Subject: AP1000 Response to Proposed Open Item (Chapter 16)

OI-SRP16-CTSB-42 R1

AP1000 Response to Proposed Open Item (Chapter 16)

#### Request for Additional Information Related to Information in APP-GW-GLR-137

Figure 7.2-1 (Sheet 5 of 20)  
 Functional Diagram  
 Core Heat Removal Protection  
 and Reactor Coolant Pump Trip

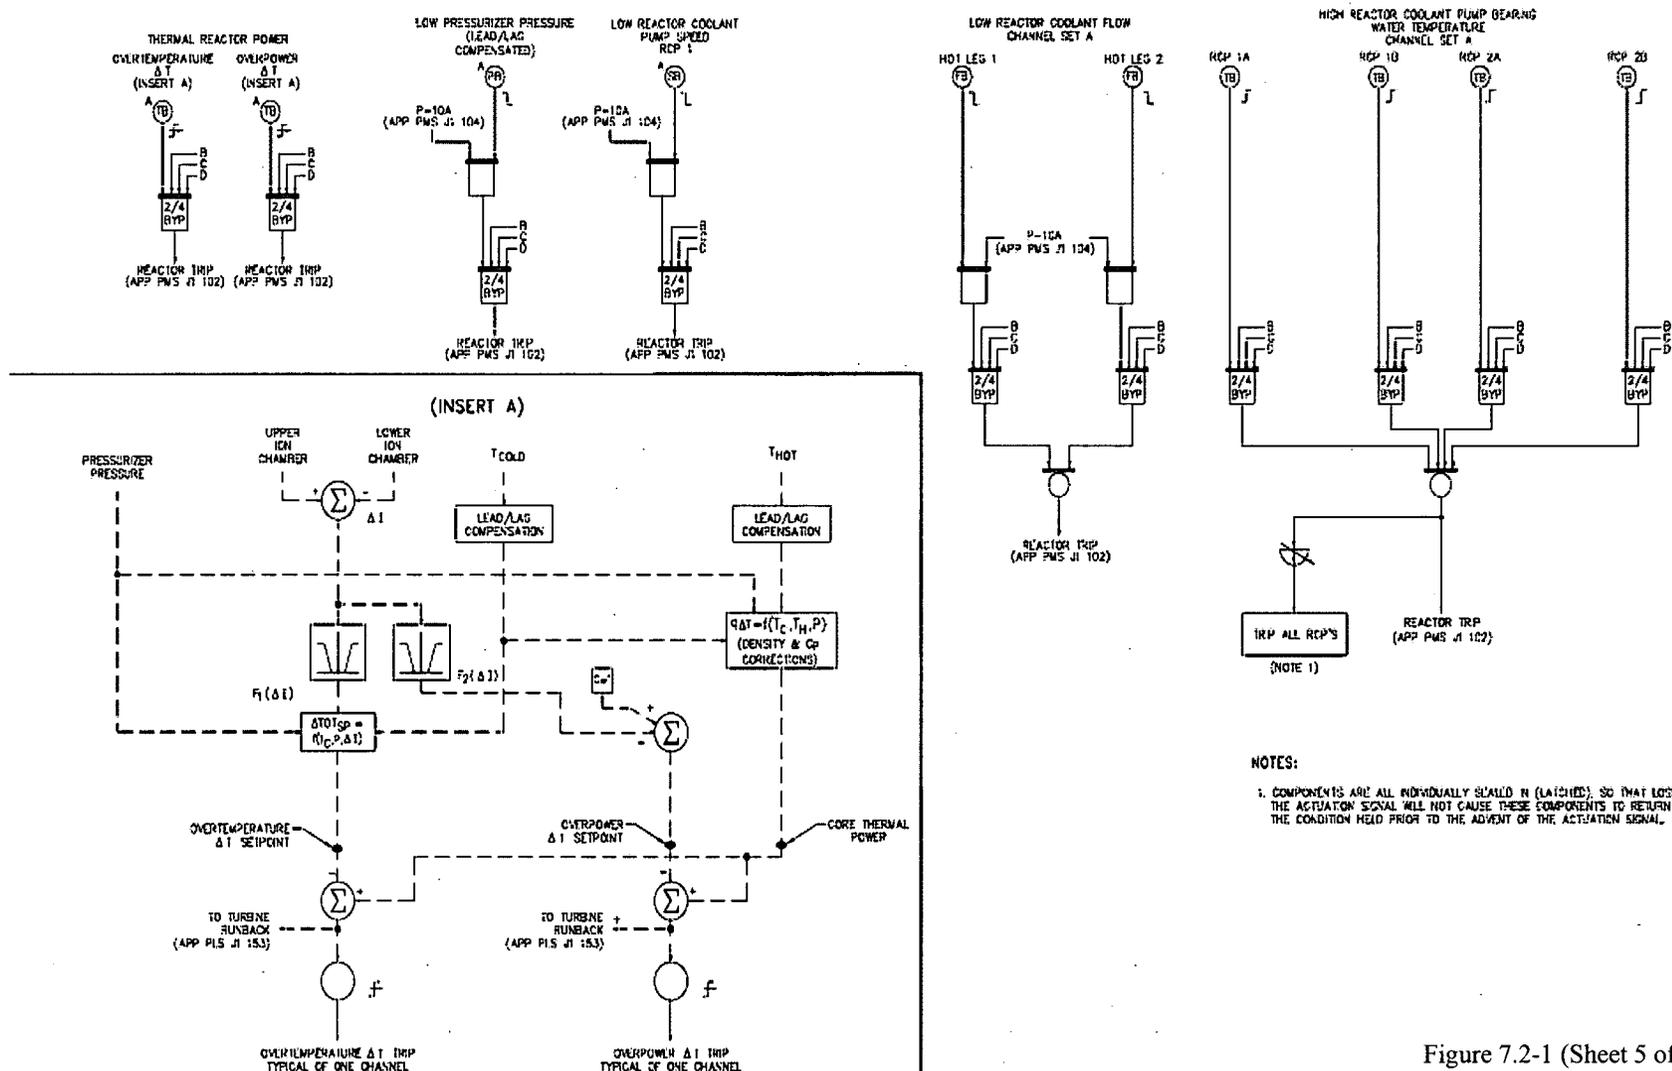
- 12.) Time constants have been added in the dynamic compensation equations given in the topical report that are not seen in corresponding logic diagrams in the DCD. Specifically, DCD Tier 2 Figure 7.2-1 (Sheet 5) should be updated to include all time constants as appropriate.

**Response to 12:** See attached Figure 7.2-1 (Sheet 5 of 20) for change to Figure to make it consistent with the terminology provided in topical report.
